Figure 2. Reflector Placement

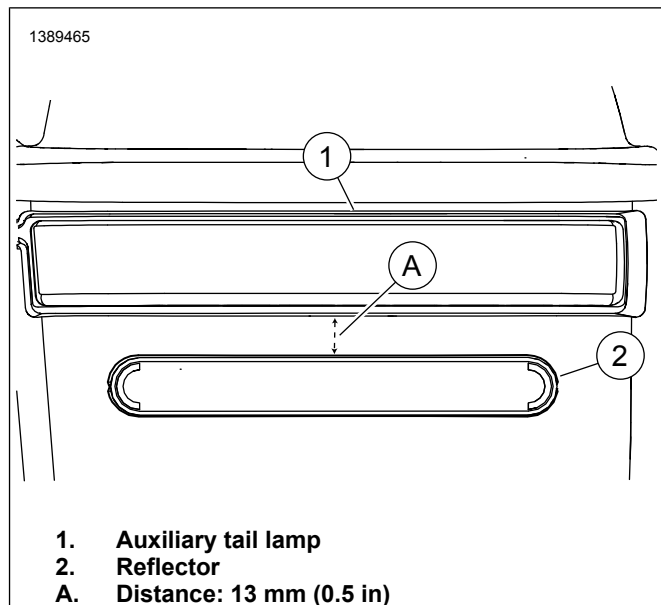
- See Figure 2. Mark reflector location.
 - Clean the reflector mounting surface with a 50:50 mixture of isopropyl alcohol and water. Allow to dry completely.
 - See Figure 2. Place reflector (2) on rear of saddlebag centered and Distance: 13 mm (0.5 in) below auxiliary tail lamp (1).
 - Mark location with a grease pencil.

- Install reflector.
 - Remove the adhesive backing from reflector.
 - Place reflector in marked location.
 - After placing reflector, apply even pressure across entire surface for 15 s.
 - Wait 20 min before touching reflectors.
